Released Engineering Change Notice

Product	XB14
Title	Eliminate hum on stereo i/p. Reduce switch click.
Date	16/03/09

Stereo PCB

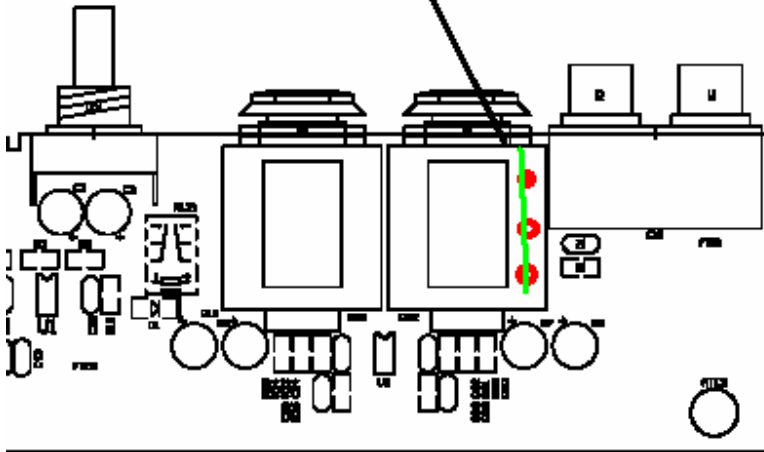
Details Of Change
<p>Add link to all Iss1 stereo & USB assemblies (003-902 & 003-903). See drawing below. Add R95 & R96 to stereo & USB assemblies (003-902 & 003-903).</p> <p>Up-issue the PCBs to Issue 2 (AG7454 & AG7455)</p>

Reason for change
<p>1/4" Stereo channels can emit hum when no input is connected and gain/channel fader is up. Reduce on clicking from on switches.</p>

Link pins on jack

USB PCB

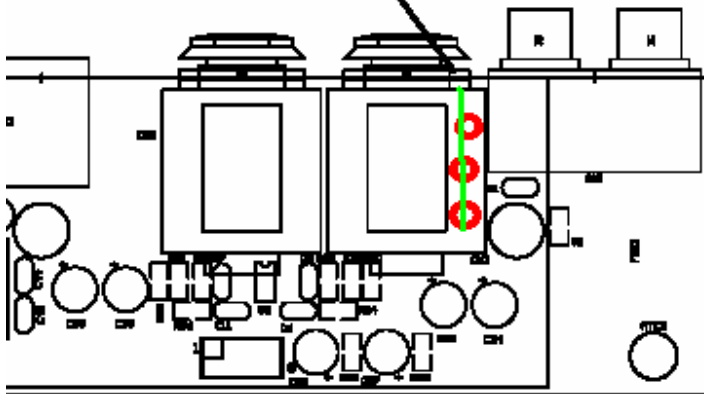
Link pins on jack
